Summary of Written and Oral Submissions

Zoning By-law Amendment – 8900 Jeanne d’Arc Boulevard North

Council considered all written submissions in making its decision and Carried the report recommendations with an amendment to replace Documents 1, 2 and 3 of the staff report with corrected versions, as follows:

Document 1 – Location Map

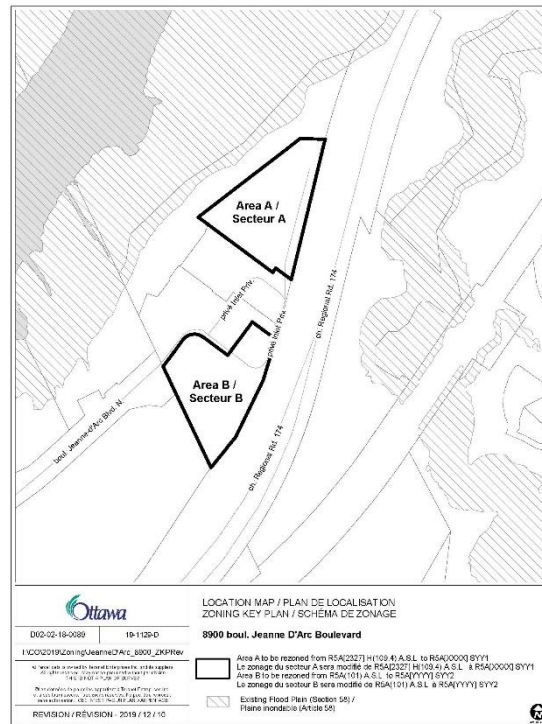
WHEREAS clarification is needed to Documents 1, 2 and 3 to ensure that the schedules which set out maximum building heights apply to the correct areas of the site.

1. That Documents 1, 2, and 3 to the said Report be deleted and replaced with the attached Revised Documents 1, 2, and 3 respectively.
